Outbound Maneuvers without South Capitol Street Oval

Outbound Maneuvers with South Capitol Street Oval

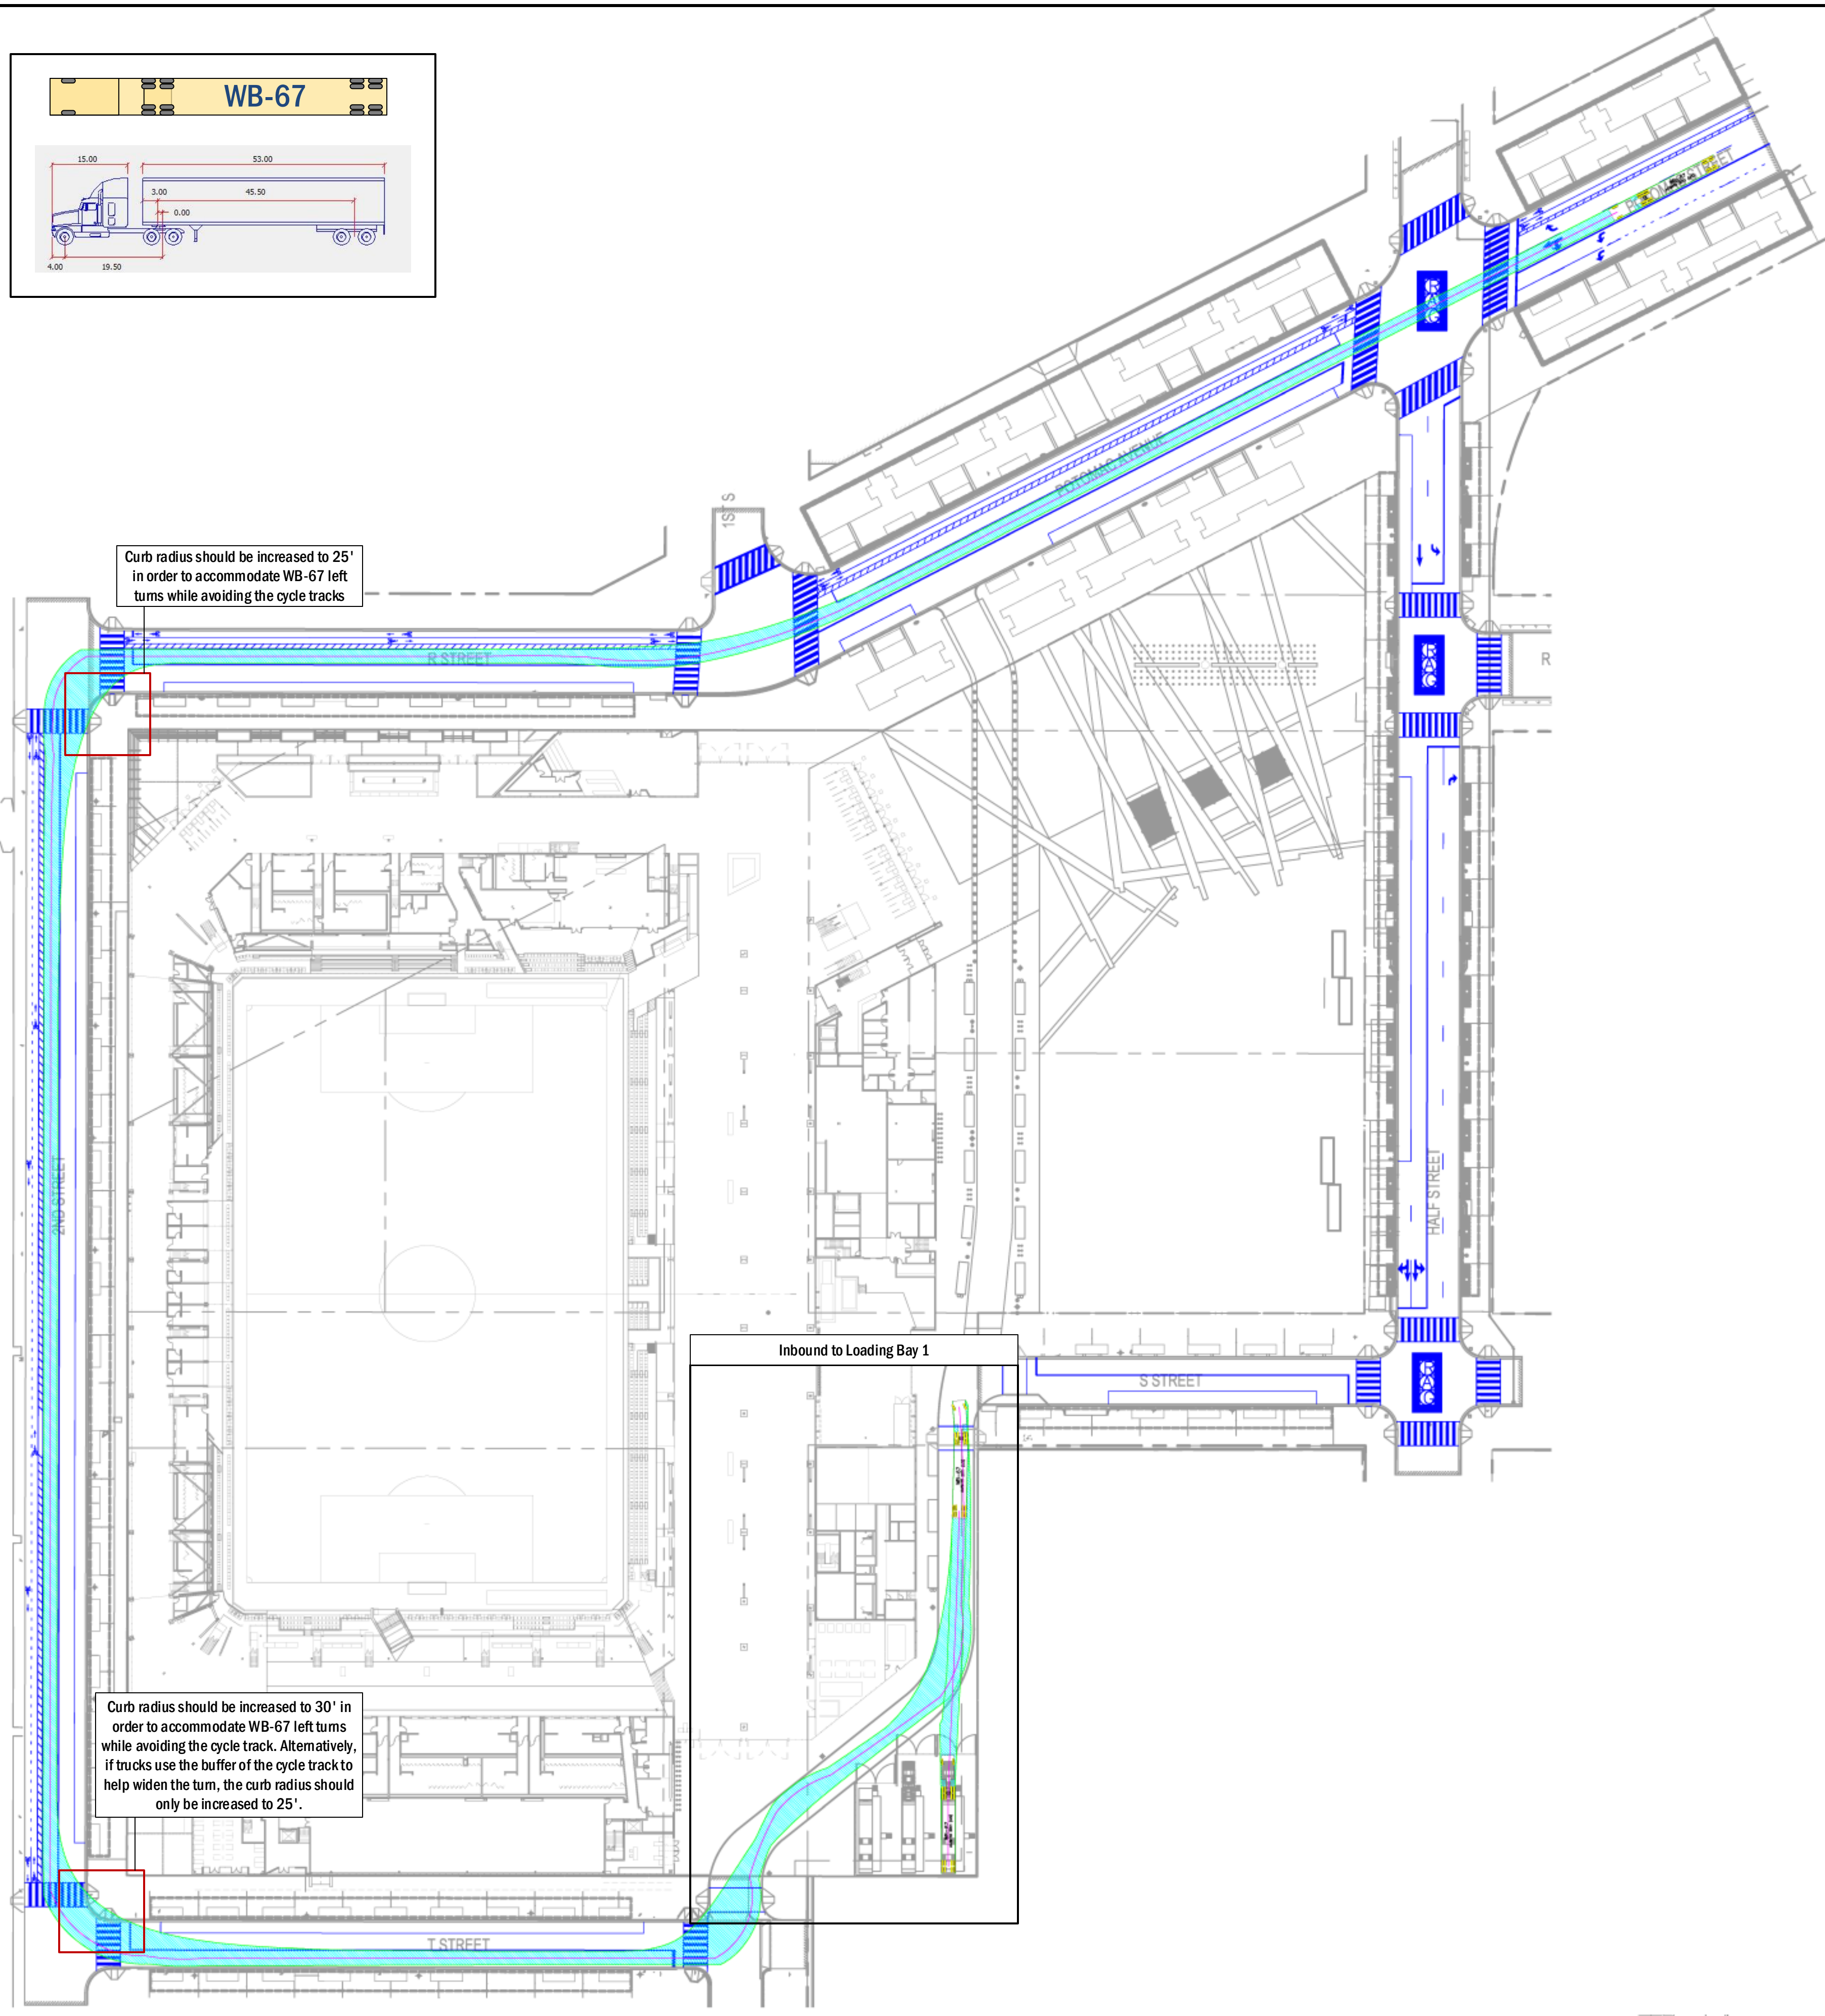
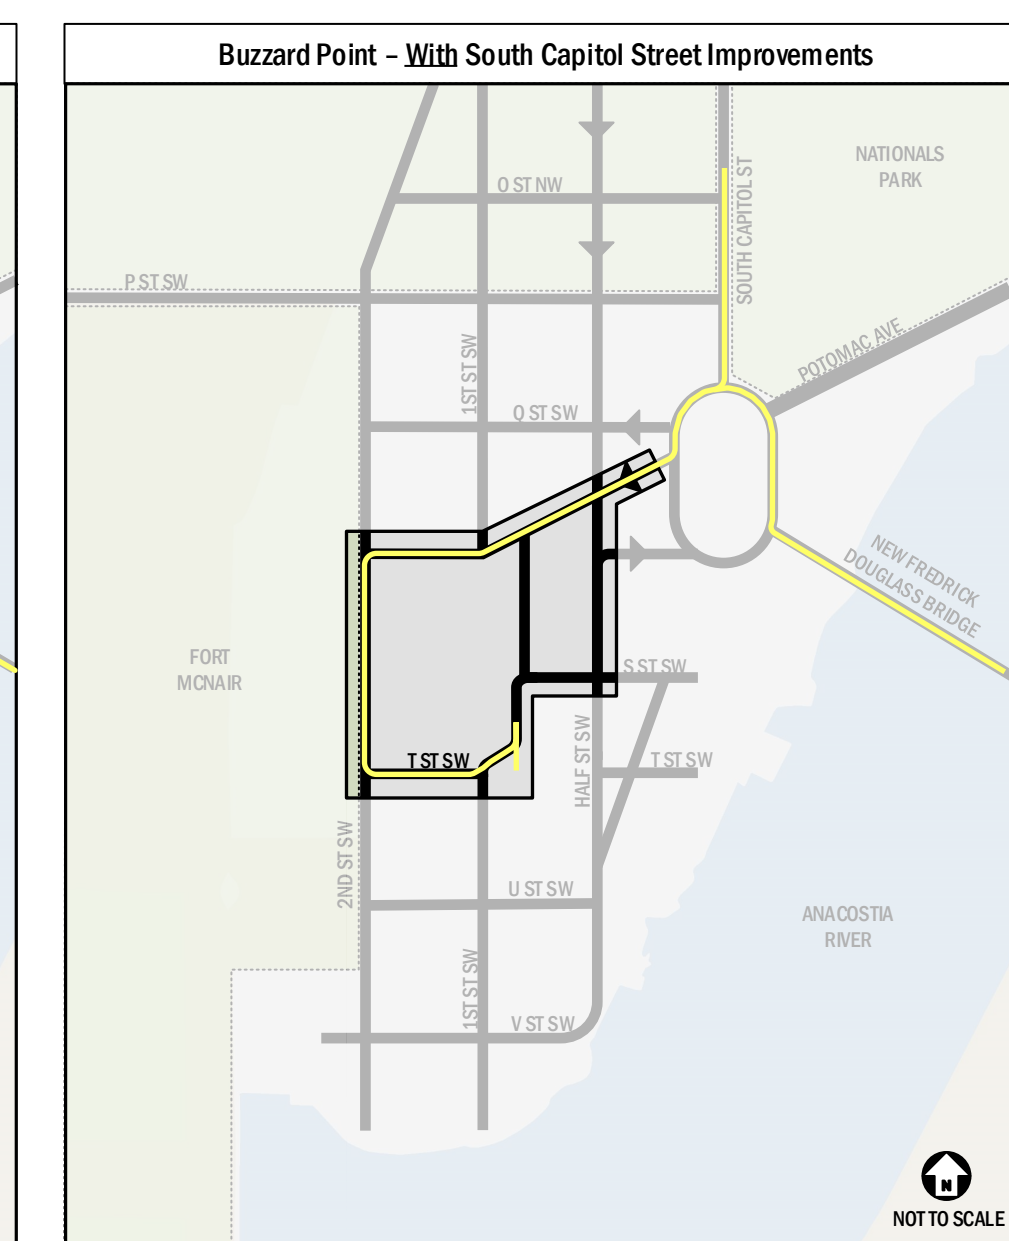
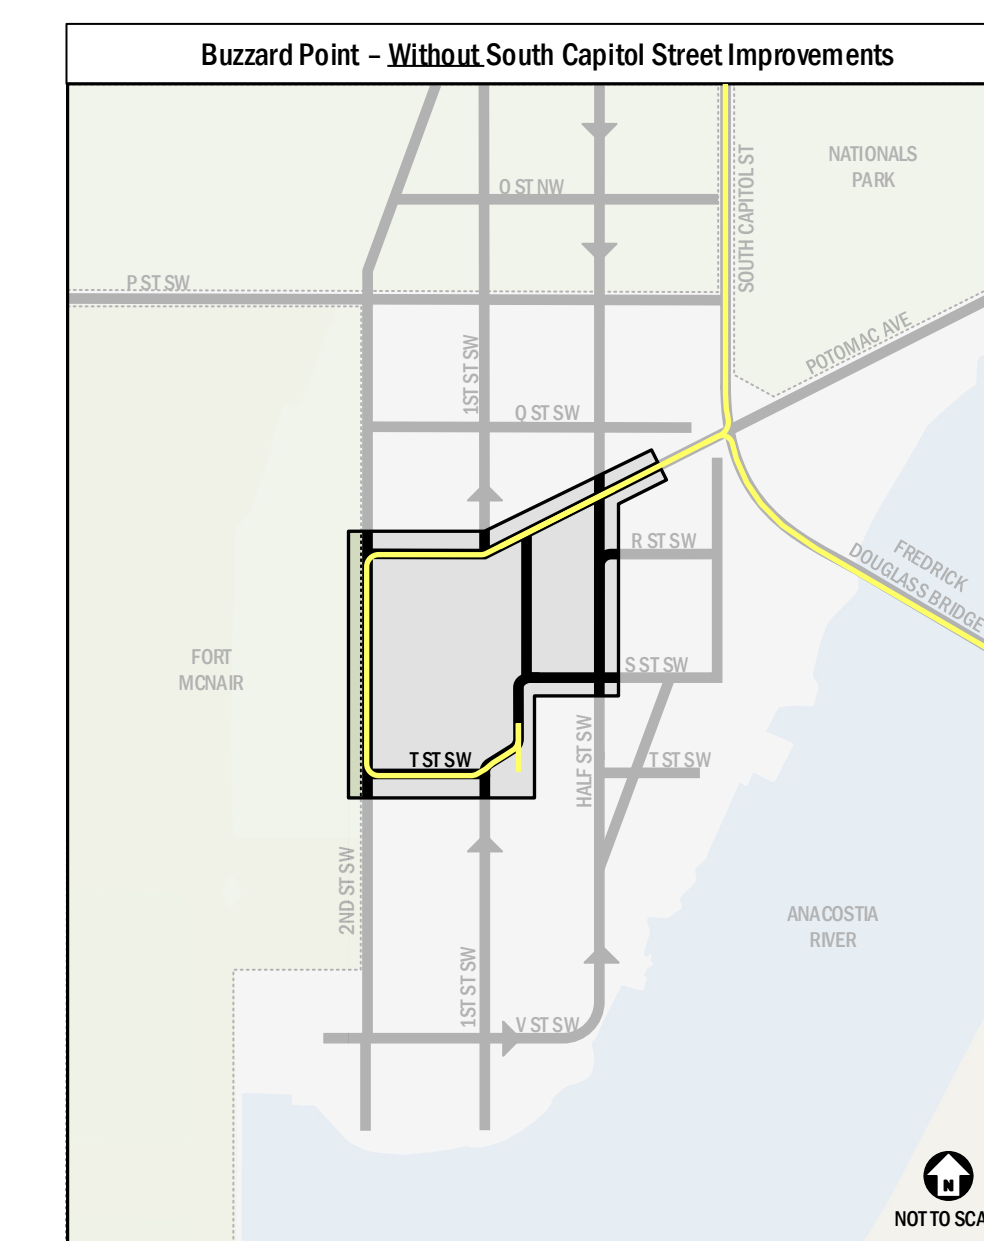
Curb radius should be increased to 25' in order to accommodate WB-67 left turns while avoiding the cycle tracks

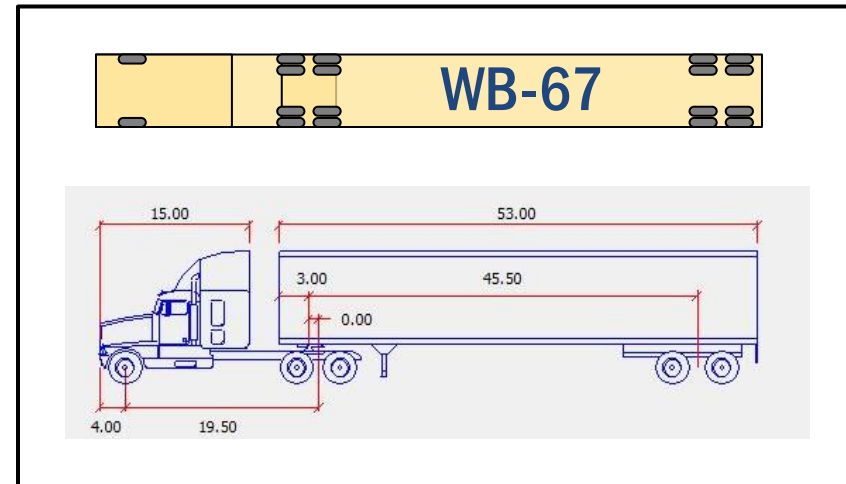
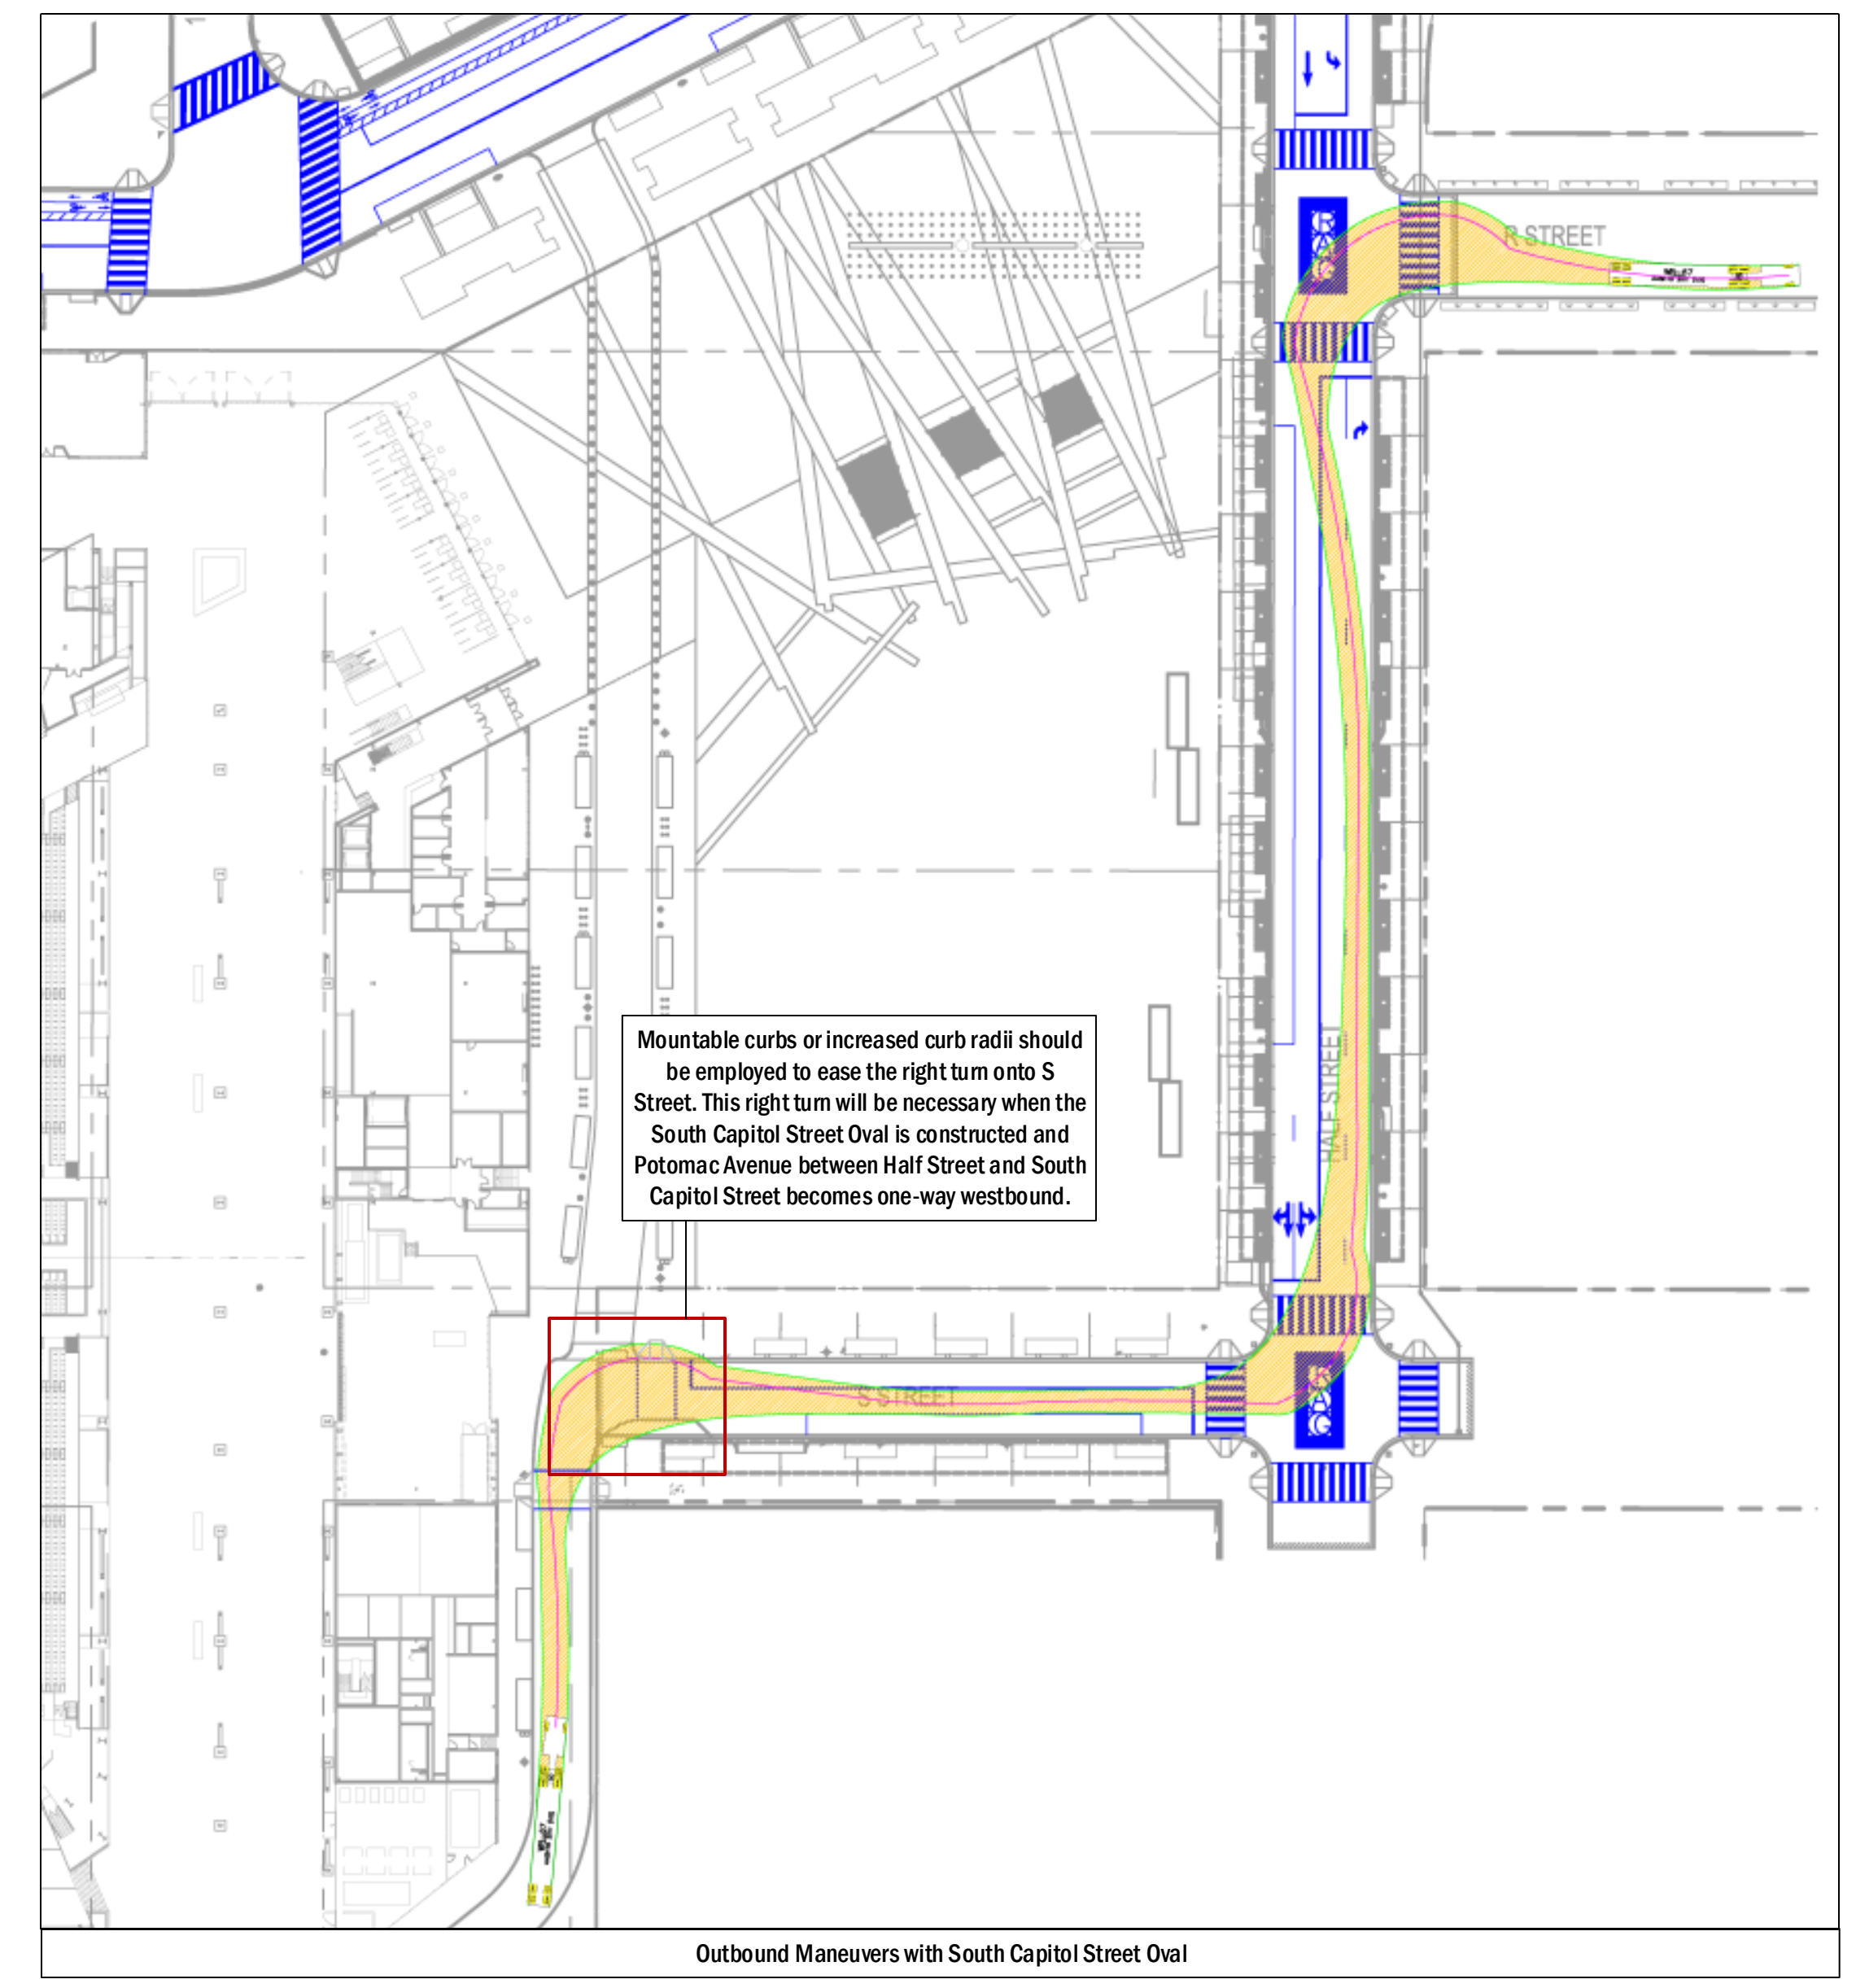
Curb radius should be increased to 30' in order to accommodate WB-67 left turns while avoiding the cycle track. Alternatively, if trucks use the buffer of the cycle track to help widen the turn, the curb radius should only be increased to 25'.

WB-67 trucks may require the cycle track buffer space to make the right turn out of the realigned First Street

Curb radius should be increased slightly or mountable curbs should be employed to ease the right turn out of the realigned First Street
